Humanetics Innovative Solutions, Inc.

Jaw / C4 Contact Issue

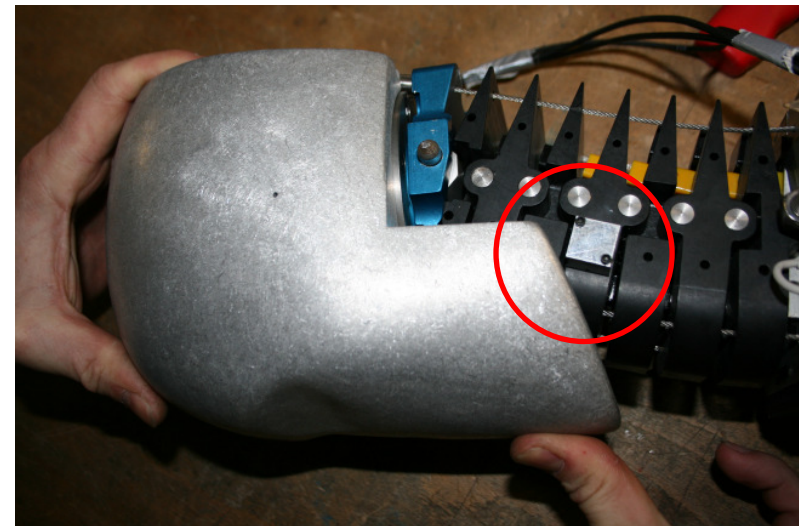
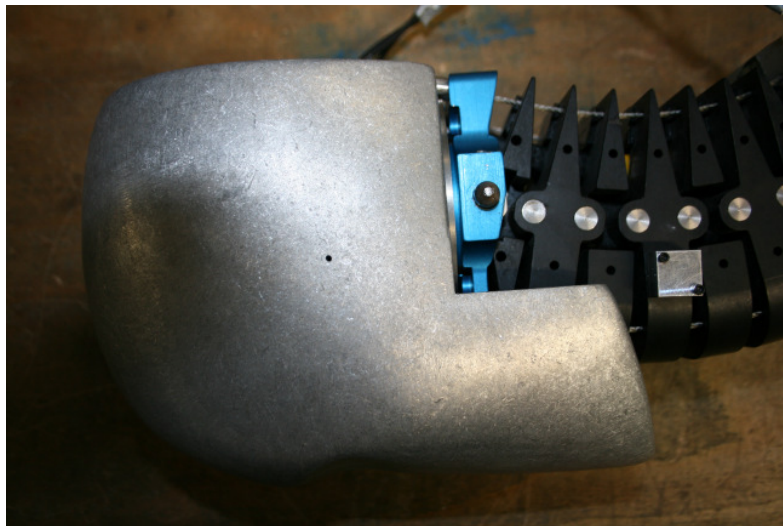
It was observed that during dynamic testing the jaw can still get in contact with the C4 accelerometers and cube respectively. This issue has not been brought to our Attention since the modification made to the C4 vertebrae back in Oct. 2001 (moving C4 cube 6mm rearwards)

Modify skull and skin in order to have more clearance when the head is rotating forward (similar to ptoposed new head design).
